## PLAT COMMITTEE

February 12<sup>th</sup>, 2025

<b>Case Number:</b>	2025-PLT-004
<b>Property Address:</b>	6725 Grandview Drive (Approximate Address)
<b>Location:</b>	Washington Township, Council District #2
<b>Petitioner:</b>	Weihe Engineers, Inc, by Joshua Werner
<b>Zoning:</b>	D-3
<b>Request:</b>	Approval of a Subdivision Plat to be known as Grandview Trails, dividing 0.86-acre into two lots.
<b>Waiver Requested:</b>	None
<b>Current Land Use:</b>	Residential
<b>Staff Reviewer:</b>	Kiya Mullins, Associate Planner

Exhibit 2: Plat split of 6725 Grandview Drive.

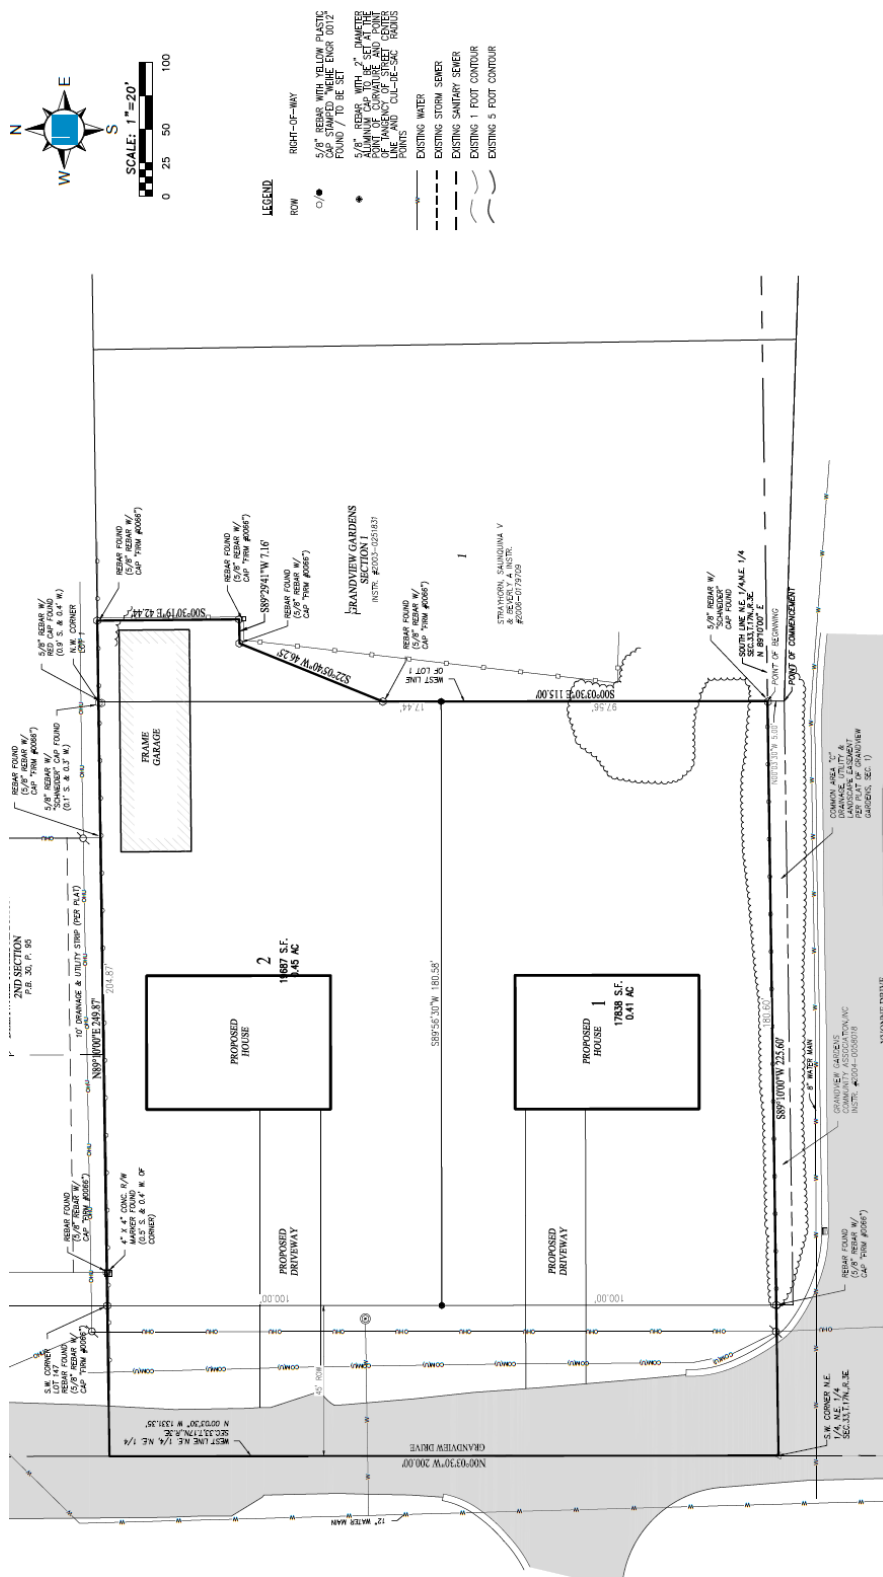
Staff recommends that the Plat Committee **approve** and find that the plat, file-dated January 3<sup>rd</sup>, 2025, complies with the standards of the Subdivision regulations, subject to the following conditions:

The subject site is 0.86 acres in a D-3 zoning district. If approved, this plat petition will split the existing parcel into two (2) parcels. One single family dwelling is currently planned to be built on each newly created parcel.

Each of the newly created parcels will face Grandview Drive, and driveways will be constructed connecting Grandview Drive to the front of each of the proposed dwellings.

No sidewalks exist along Grandview Drive and are not planned to be constructed with this plat petition.
